**SUBJECT: G2.8 Connector Dust Seal**

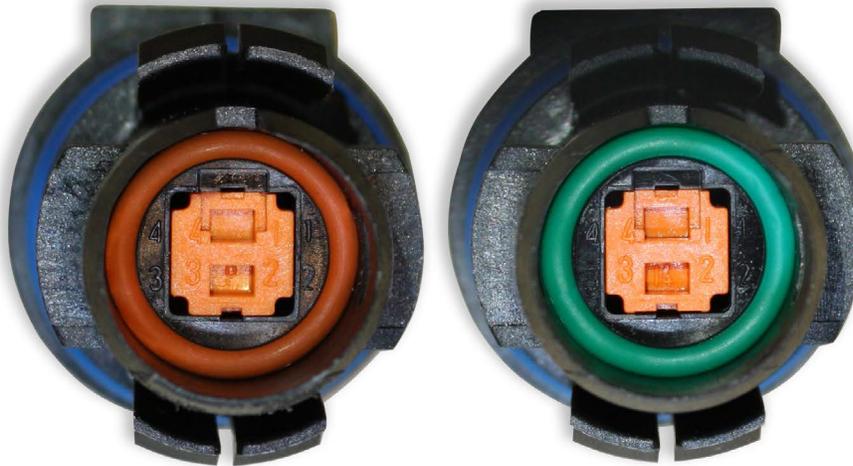
Occasionally, Alliant Power is forced to replace the electrical connector on G2.8 Injectors due to wear or damage. These new connectors are received by Alliant Power complete with the internal and external seals already installed. There is one visible difference with the new connectors that are used during the remanufacturing process, the internal dust seal.

The seal used by Alliant Power, in both the remanufacturing process as well as the AP0002 G2.8 Injector Seal Kit, is orange in color. The seal supplied with new connectors is green in color.

While the color of the seal is different, the reliability of the seal is consistent and will not affect the performance of the injector or the integrity of the electrical connection. The two types of seals may also be intermixed on an engine with no influence on performance.
